Appendices Part 4

Comments INDIV-200s

From: ARCF_SEIS <ARCF_SEIS@usace.army.mil>
Sent: Wednesday, January 31, 2024 1:14 PM
To: Sutton, Drew; ARCF_SEIS
Cc: publiccommentARCF16@water.ca.gov
Subject: [EXT] FW: [Non-DoD Source] American River Common Features (ARCF) 2016 Draft Supplemental Environmental Impact Statement/Subsequent Environmental Impact Report (SEIS/SEIR) – December 2023 Report and Appendices

Figure 9

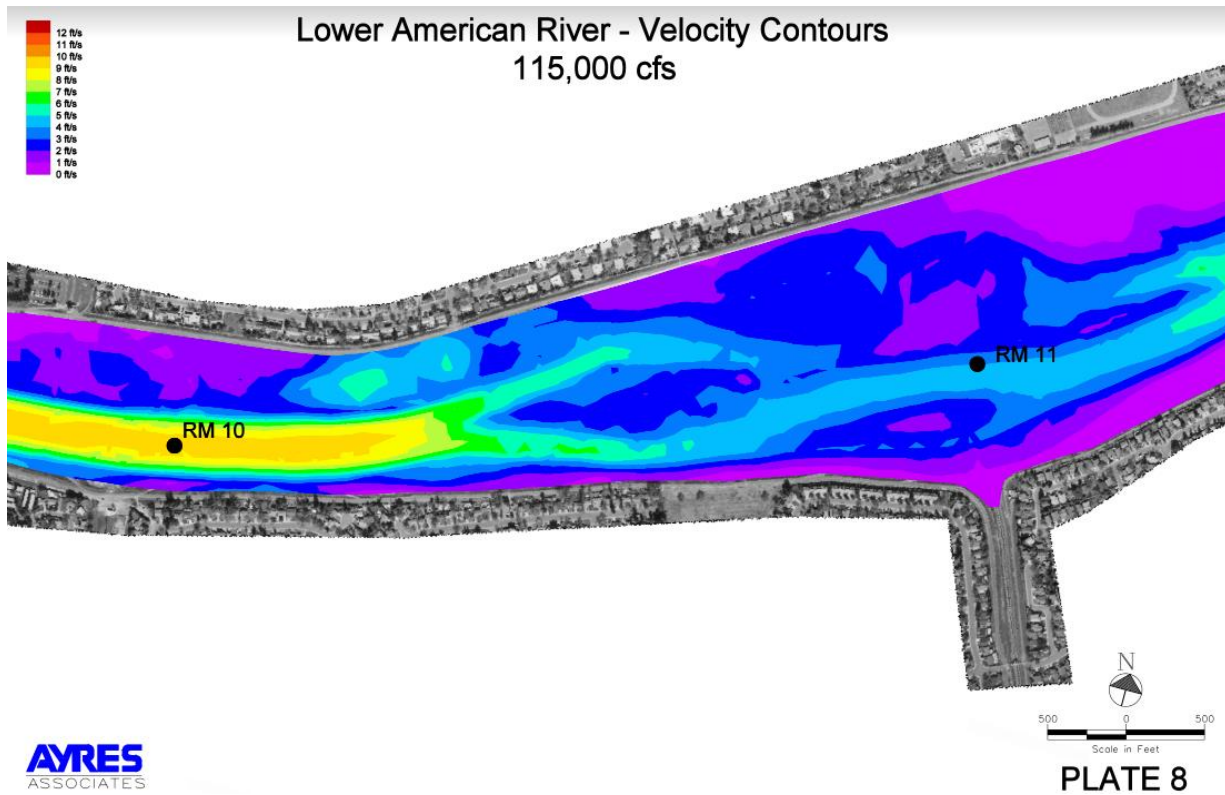
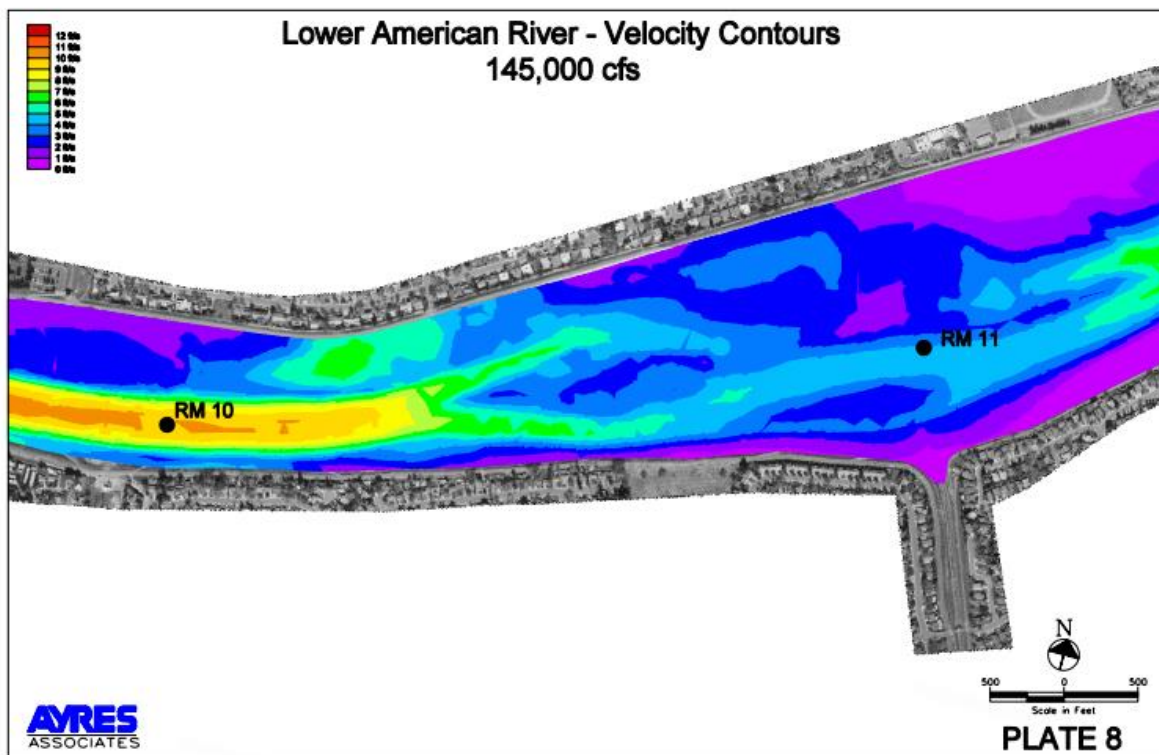
11 USACE’s velocity contour maps may show even lower velocities along the banks. The quality of the maps seems biased towards justifying the most extreme possible erosion measures, as the maps are too zoomed out to precisely ascertain river flow velocities along the banks, except for river mile 6.6-7.5, which happens to be part of the Lower American River where velocities are fastest along the banks. For this segment of the river, USACE provided high quality, zoomed in maps (Figure 4). None of the other sub-reaches of the Lower American River got such scrupulous treatment. For left bank river mile 10-11, where USACE proposes three launchable rock toes and a launchable rock trench, we can better perceive the river’s flow behavior by looking at the velocity contour maps from the *2017 Lower American River Streambank Erosion Monitoring Report*, which were derived from the same hydraulic modeling as the velocity contour maps provided in the 2016 *General Reevaluation Report* (GRR).⁶⁶ The more high quality maps from the 2017 report show that from 115,000 cfs to 145,000 cfs, there is little change in the velocity of flows along left bank river mile 10 to 11. In both cases, the water is almost stagnant, moving at 0-2 ft/sec for most of the river mile and rising to only about 4-6 ft/sec at around left bank river mile 10.⁶⁷

145,000 cfs does not quite get us to the 160,000 cfs mark, but it should be emphasized that there was very little change from 115,000 to 145,000 cfs, that some of USACE's experts noted low velocities near levees at 160,000 cfs between river miles 9.8 and 10.5, and that even the discernable part GRR's low resolution velocity contour maps show that at worst river velocities reach 6-7 ft/sec around left bank river mile 10.

Figure 1. Bank Protection and Launchable Rock Trench Typical Design.

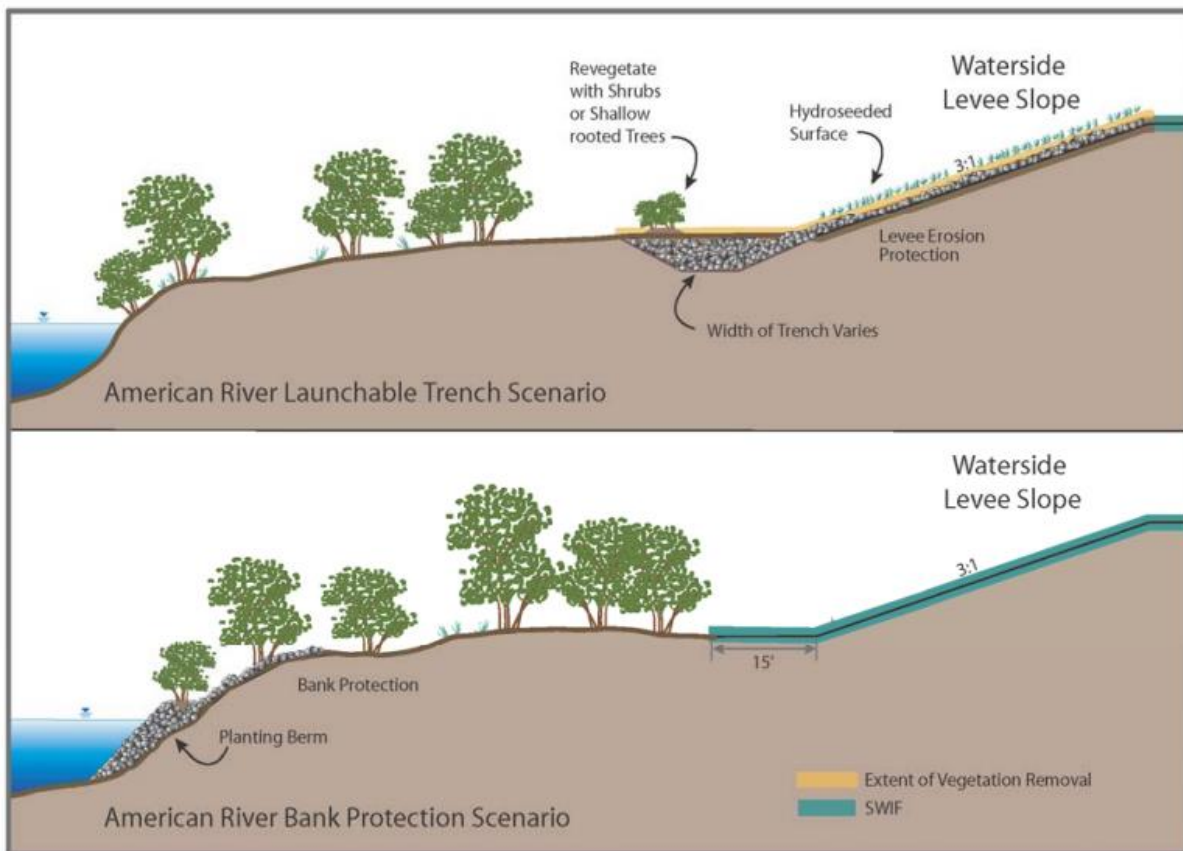
figure 1 of the Final EIS/EIR (figure 4-9 in the *General Reevaluation Report*) shows that tree removal would only occur on the levee itself and at the base of the levee.¹⁰⁰ It indicates that USACE would spare most trees on the riparian bench and on the natural levee slope. For “American River Bank Protection Scenario,” no part of the bank is highlighted for vegetation removal or tree clearing.¹⁰¹ From these diagrams, an apprehensive citizen could reasonably conclude USACE would remove few trees, if any at all, while installing either launchable rock trenches or bank protection.

Figure 4.1-1. American River Erosion Contract 3B and 4B Land Cover Types

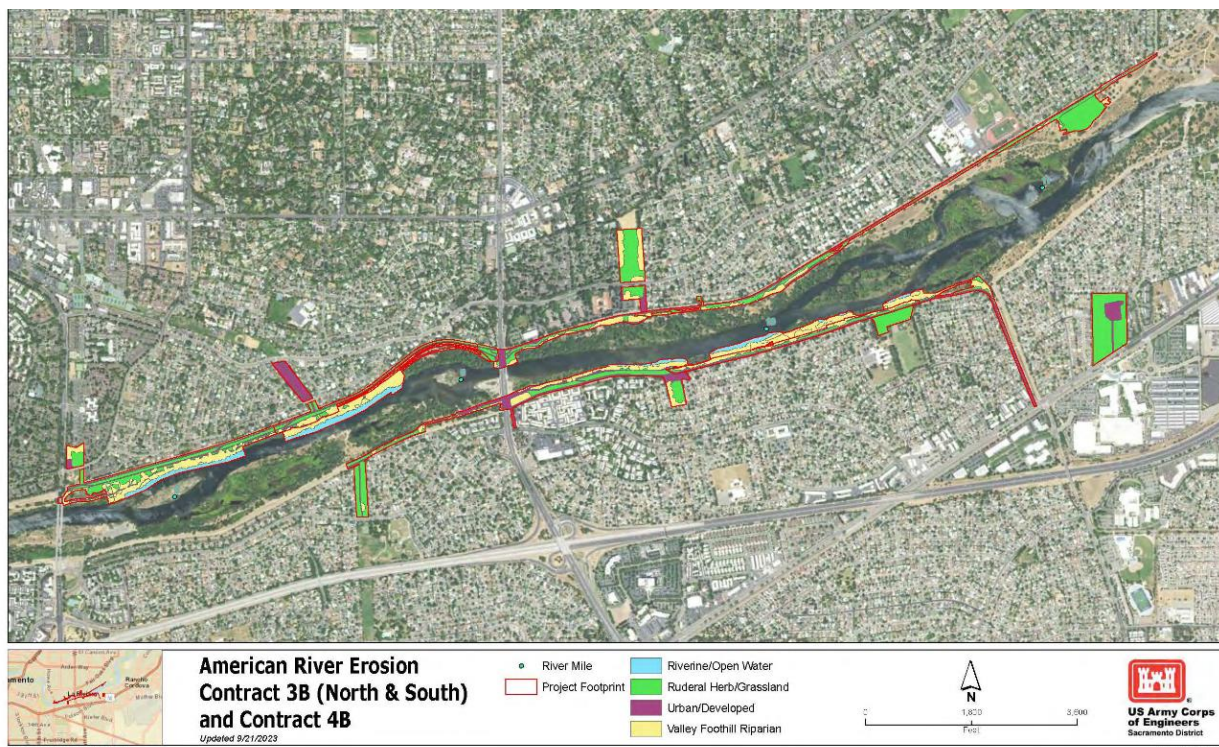
20 [USACE provides a low-quality image of the various habitats in the project footprint but fails to distinguish with any detail the different habitats and how much tree loss each segment will suffer.¹¹⁵

Figure 3.5.2-3. American River Erosion Contract 3B Project Footprint

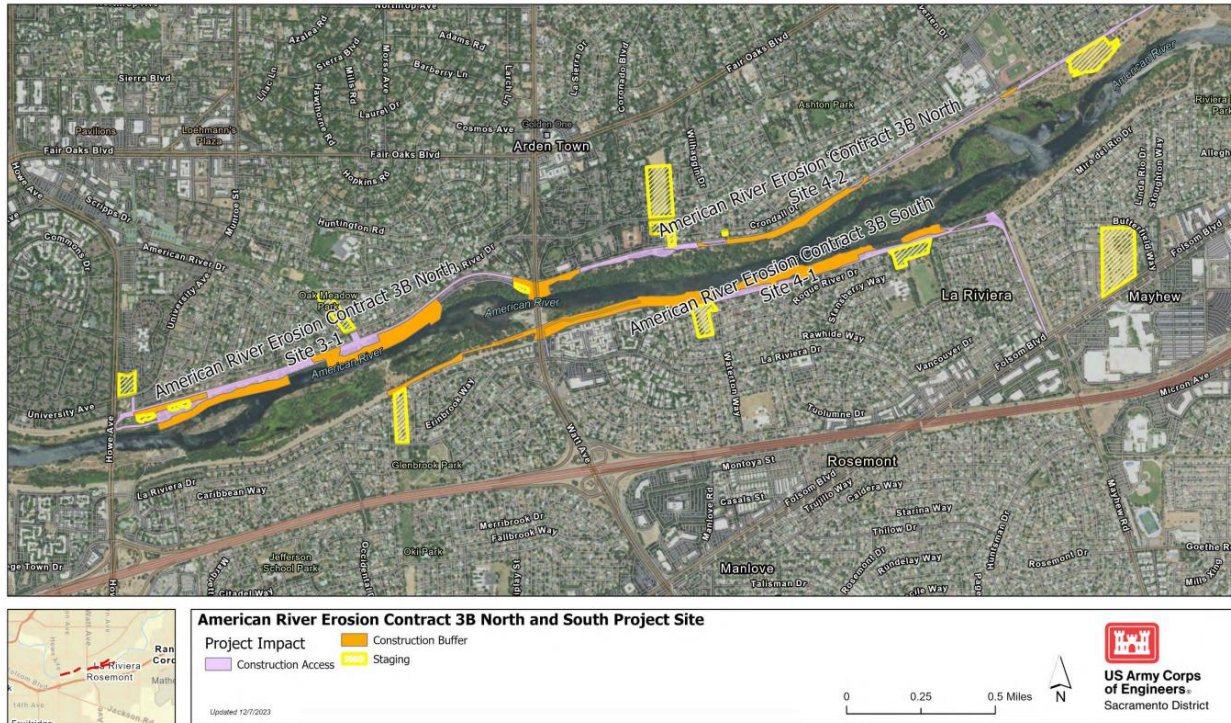
In addition to the low-quality image of the various habitats in the project footprint, USACE provides a vague and confusing map of “project impacts.”¹¹⁶ The project impacts maps identify three kinds of areas within the project footprint: construction access, construction buffer, and staging. USACE leaves it up to the public to interpret these terms. Contrary to standard practice, USACE does not define these terms in the SEIS/SEIR. An apprehensive citizen could reasonably surmise that construction access refers to where construction equipment will be moving and construction buffer to the areas where construction will occur. Yet consider the project impact map for Contract 3B South.

Figure 3.5.2-9. American River Erosion Contract 3B South Site 4-1 Details

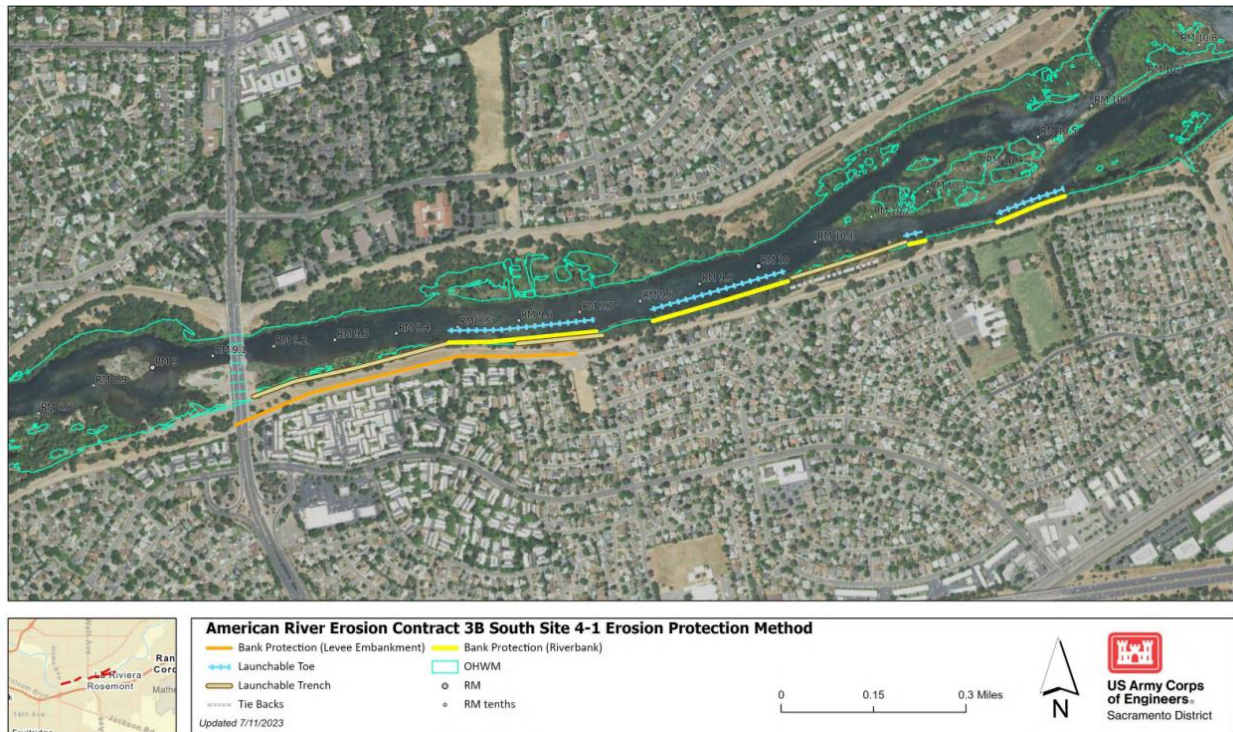
By contrast, the visual projections of USACE's proposed work for the 2023 Draft SEIS/SEIR are vague and overly generalized.¹¹⁹ Instead of site-by-site diagrams for Contract 3B South, USACE provides a zoomed-out map with lines indicating where launchable rock toes, trenches, and bank protection will be implemented. It is impossible from this visual (figure 27

below) to ascertain any meaningful environmental or recreational impacts. Instead of site-by-site descriptions of soil filled revetments, USACE simply provides figures which illustrate the general concept of launchable rock toes, trenches, and planting benches (see figure 16).¹²⁰ The pictures of American River Contract 1 and 2 already demonstrate that we can expect little resemblance between USACE's conceptual diagrams and the final work.
